PRELODGE MENT PANEL ADVICE EIS CONSULTATION AND ADVICE

PROPERTY: 6-8 Julius Avenue, North Ryde

PRELODGE MENT No: PRL 2024/0013

DEVELOPMENT: Proposed construction and operation of a new Data Centre that includes tree removal, earthworks and landscaping, carparking and associated infrastructure. The Application is prepared as a State Significant Development Application (SSDA)

Figure 6. Extract showing Council 1% AEP Flood Risk Map on the left and PMF Flood Extent on the right (Source: Ryde Maps)

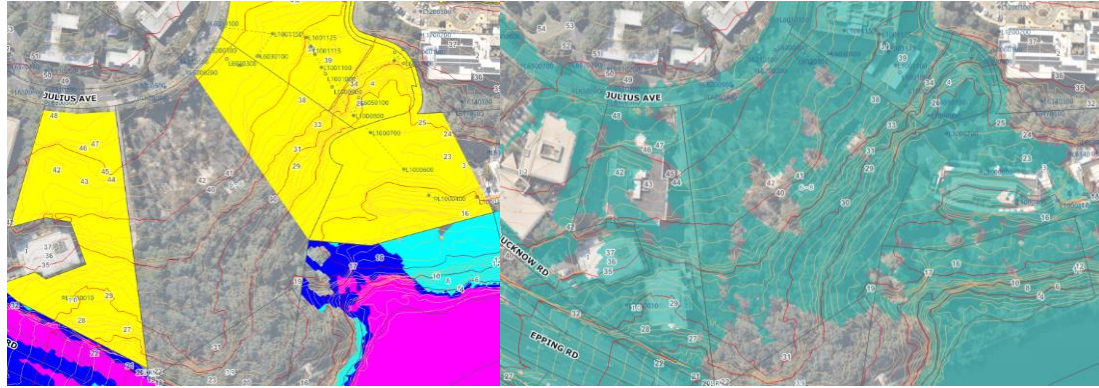
The site is found to be subject to flood inundation from Julius Avenue during the PMF and 1% AEP event. Refer to *Figure 5*. below.

For the proposed Data Centre, the floor levels from Basement to Level 1 are nominated to be lower than existing natural ground subject to flooding during both 1% AEP and PMF events.

There are concerns regarding the potential flood impact of the Data Centre development on neighbouring sites during the PMF event as well as flood inundation within proposed building. Both these concerns shall be subject to review via detailed flood analysis.

The EIS is to include a detailed Flood study report that considers the following:

Figure 12. Proposed Level 6 plan extract (Source: Greenbox Architecture)

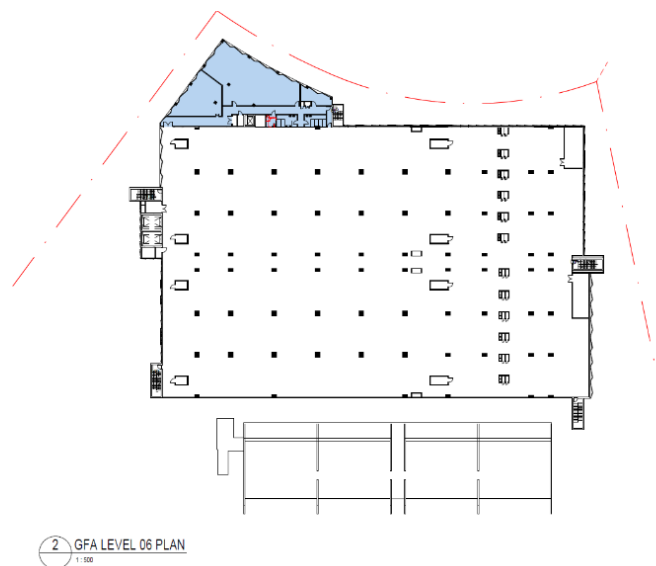
The Level 6 is shown as a large plant room with only 484sqm GFA calculated from the office area at the north-western corner. It is unclear of the function and necessity of this plant room. Council also requests clarification of the plant room on Level 6. Investigate the option of relocate GFA or other uses to this level to reduce the building footprint and expand the setbacks. Please refer to *Figure 12*. below.

Figure 13: Mark up of possible area (Pink) for STSS to be located (Source: City of Ryde Council)

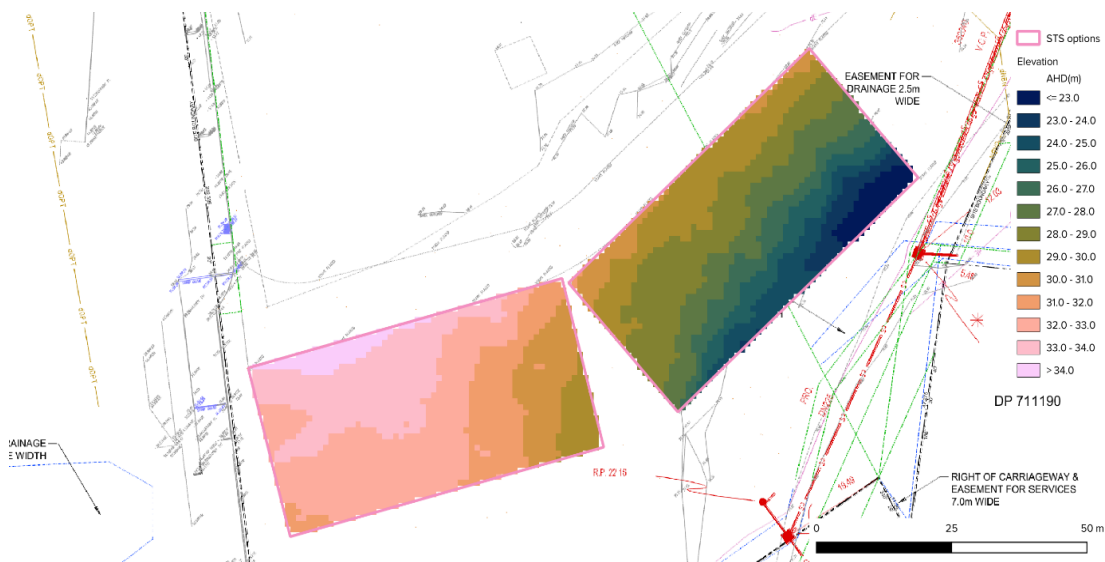
The proponent is requested to engage with Ausgrid to consider the potential for the facility to be located adjacent to the boundary with 10 Julius Avenue, and the potential for the facility to be recessed at the high side (adjacent to the access road) to minimise fill requirements at the low side of the STSS.

Council notes that the location of the substation will also depend on vegetation impacts and its location on important ecological. Given this the applicant is to clearly demonstrate in the EIS, why the final location of the STSS is most suitable.
